PRODUCT UPDATE

Number 20

650 Oasis™ WetSeal Improvements

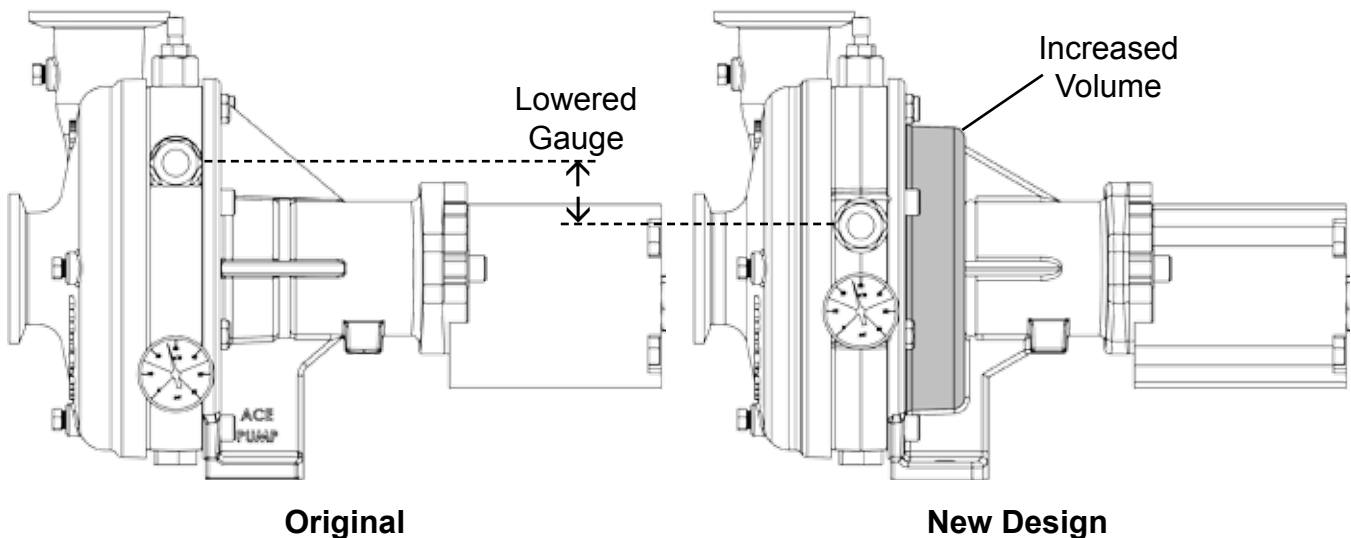
We are increasing the fluid volume in the seal chamber to reduce service intervals. This was accomplished by creating a bowl shape inside the frame's outer mounting surface. We are also increasing the air volume in the seal chamber to improve pressure stability. This was accomplished by lowering the site glass and corresponding fluid level.

The new parts are interchangeable and may be used for repair of older pumps. The original parts will be discontinued and superseded by the new parts.
